Access Compliance Report

Public Rights-of-Way

Intersection ID: 31686	Main Street: GALLISON_AV	Cross Street: SNOWDROP_DR	Location: NW
ADA ID: 19BDF45DB436	Ramp Type: PerpDiag	Initial Pass/Fail: Fail	Overall Compliance: No
Severity Score: 21.25			
Codes/Mitigation Info/Possible Solution		Field Measurements/Component Compliance

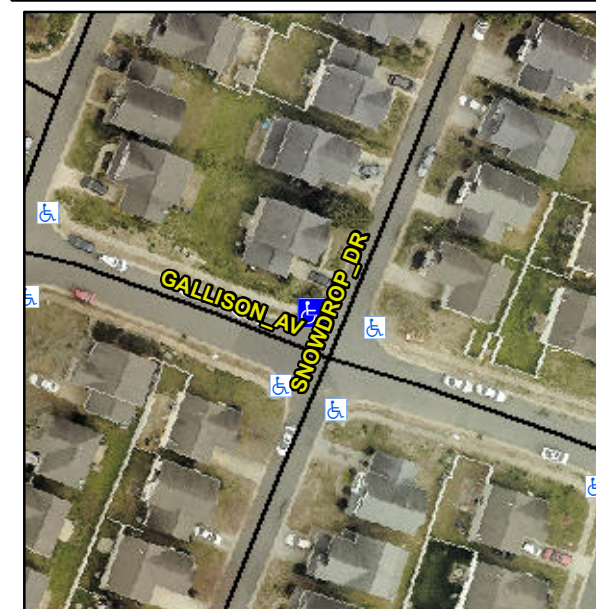
R304.5.1, R304.5.3

Compliance	Description	Data	Compliance	Description	Data
N/A	Ramp Length (in)	48.0	Yes	Ramp Slope (%)	7.7
No	Ramp Width (in)	36.0	No	Ramp XSlope (%)	6.6
N/A	Flare Type LT	N/A	N/A	Flare Type RT	N/A
N/A	Flare Slope LT (%)	N/A	N/A	Flare Slope RT (%)	N/A
N/A	Flare Traversable LT?	N/A	N/A	Flare Traversable RT?	N/A
N/A	Landing Length (in)	N/A	N/A	DWS Provided?	N/A
N/A	Landing Width (in)	N/A	N/A	DWS Contrast?	N/A
N/A	Landing Slope (%)	N/A	N/A	DWS Length (in)	N/A
N/A	Landing X Slope (%)	N/A	N/A	DWS Full Width?	N/A
N/A	Landing Curb? (Y/N)	N/A	N/A	DWS Offset (in)	N/A
N/A	Shared Landing?	N/A			
N/A	Gutter Ponding?	N/A	N/A	Gutter Slope (%)	N/A
N/A	Gutter Lip Ht (in)	N/A	N/A	Gutter X Slope (%)	N/A
N/A	Painted X Walk1?	No	N/A	Painted X Walk2?	No
	X Walk 1 Direction	To SW		X Walk 2 Direction	To SE
N/A	X Walk 1 Width (in)	N/A	N/A	X Walk 2 Width (in)	N/A
	X Walk 1 Slope (%)	2.8		X Walk 2 Slope (%)	0.2
	X Walk 1 X Slope (%)	3.4		X Walk 2 X Slope (%)	4.9

Remove & Replace Curb Ramp With Two New Directional Ramps or Equivalent.
